Access Compliance Report

Public Rights-of-Way

(Curb Ramps)

Intersection ID: 26179	Main Street: HOLLY_HILL_FARM_RD	Cross Street: RAINTREE_LN	Location: NE
ADA ID: A89C4B97DA8F	Ramp Type: Perp	Initial Pass/Fail: Fail	Overall Compliance: No
Severity Score: 12.5			
Codes/Mitigation Info/Possible Solution		Field Measurements/Component Compliance

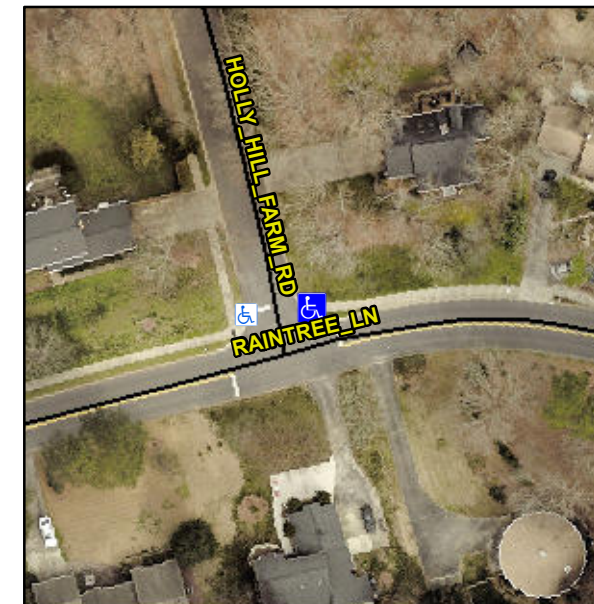
Not Found, R304.2.2

Compliance	Description	Data	Compliance	Description	Data
N/A	Ramp Length (in)	24.5	No	Ramp Slope (%)	9.0
Yes	Ramp Width (in)	48.0	Yes	Ramp XSlope (%)	0.4
N/A	Flare Type LT	N/A	N/A	Flare Type RT	N/A
N/A	Flare Slope LT (%)	N/A	N/A	Flare Slope RT (%)	N/A
N/A	Flare Traversable LT?	N/A	N/A	Flare Traversable RT?	N/A
N/A	Landing Length (in)	N/A	N/A	DWS Provided?	N/A
N/A	Landing Width (in)	N/A	N/A	DWS Contrast?	N/A
N/A	Landing Slope (%)	N/A	N/A	DWS Length (in)	N/A
N/A	Landing X Slope (%)	N/A	N/A	DWS Full Width?	N/A
N/A	Landing Curb? (Y/N)	N/A	N/A	DWS Offset (in)	N/A
N/A	Shared Landing?	N/A			
N/A	Gutter Ponding?	N/A	N/A	Gutter Slope (%)	N/A
N/A	Gutter Lip Ht (in)	N/A	N/A	Gutter X Slope (%)	N/A
N/A	Painted X Walk1?	No	N/A	Painted X Walk2?	N/A
	X Walk 1 Direction	To NW		X Walk 2 Direction	N/A
N/A	X Walk 1 Width (in)	N/A	N/A	X Walk 2 Width (in)	N/A
	X Walk 1 Slope (%)	3.1		X Walk 2 Slope (%)	N/A
	X Walk 1 X Slope (%)	7.3		X Walk 2 X Slope (%)	N/A

Remove & Replace Entire Ramp.
